# BEFORE THE OHIO POWER SITING BOARD Certificate Application for Electric Transmission Facilities Table of Contents

#### SECOND AMENDMENT CHANGE SUMMARY

AEP Ohio Transmission Company, Inc. ("AEP Ohio Transco") submitted a Certificate Application to the Ohio Power Siting Board ("OPSB") on June 13, 2018 for the Glencoe-Speidel 138 kV Transmission Line Project ("Project") in Case No. 18-0279-EL-BTX. On February 21, 2019, the OPSB issued its Certificate of Environmental Compatibility and Public Need (certificate) for the Preferred Route (also referred to as the "OPSB-Approved Route" herein). AEP Ohio Transco submitted an Amendment to the February 2018 Certificate Application to the OPSB on September 20, 2019 in Case No 19-1741-EL-BTA. On January 16, 2020 the OPSB issued the approval to amend the application.

The purpose of this Amendment #2 is to document the changes to the Preferred Route alignment since the OPSB's approval of the Preferred Route, and to seek OPSB approval of the revised Preferred Alignment. This Amendment #2 application does not provide updated information for the Alternate Route because the purpose of this amendment is to document the changes to the Preferred Rou

#### **Engineering Adjustment 1**

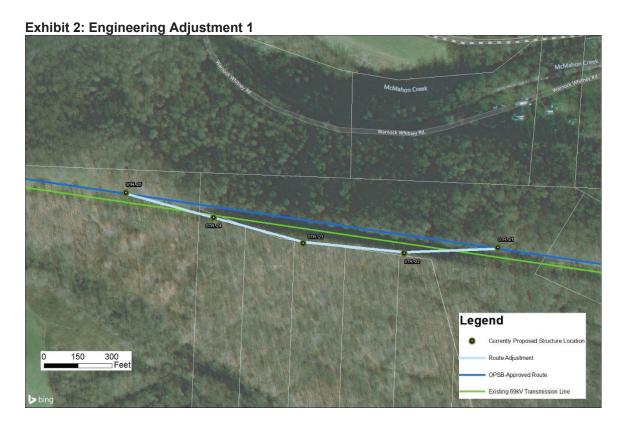
As detailed engineering of the transmission line progressed after approval of the certificate amendment application in January 2020, one alignment change, affecting 4 structures were necessary for the Preferred Route. These changes are categorized as an alignment reroute (deviations outside of the 100 foot ROW) due to safety, engineering and constructability challenges with the Amended Certificated Route. An overview of the changes are provided in Exhibit 1 and 2 below. Table 1 identifies the structure shifts associated with the alignment reroute that AEP Ohio Transco is proposing as part of this Second Amendment Application.

Engineering Adjustment 1 is approximately 0.3-mile long and occurs between Structures 21 and 25. The Company shifted proposed structures 22 and 23 approximately 76 and 96 feet, respectively, to move the proposed structures off a hillside that is too steep to safely construct a new pole line. Based on the shift of structures 22 and 23, proposed structures 24 and 25 were shifted approximately 48 and 11 feet, respectively, to converge back to the OPSB-Approved Route at structure 25. There are no additional environmental impacts. Engineering Adjustment 1 will require 6 new landowners within the proposed 100-foot right-of-way (ROW). However, the Company's ROW agents are currently in coordination to obtain easements with these landowners.
